BARRACK HOUSE

THE PARADE GROUND | DORCHESTER

AMENDMENTS TO APPROVED SCHEME | JUNE 2021

REVISED LAYOUT

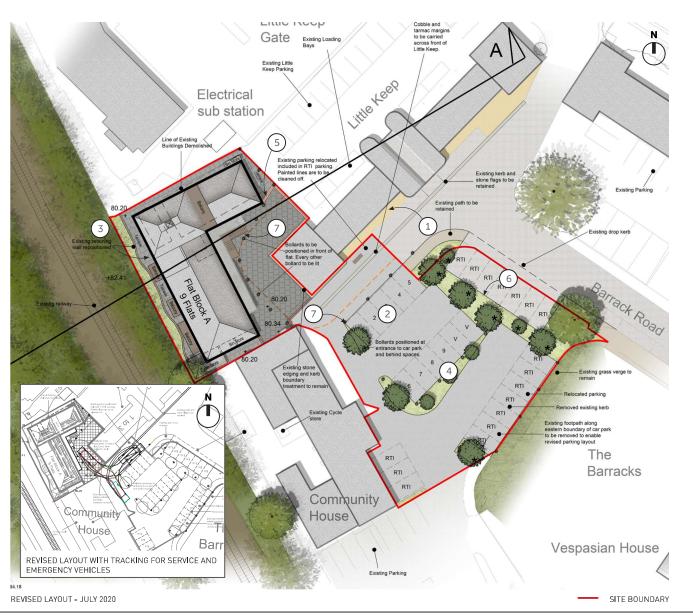
The approved layout has been revised to incorporate the architectural changes to the balconies and external stairs to Barrack House only, to suit Building regulations.

The access remains as the consented scheme, allowing access for service and emergency vehicles.
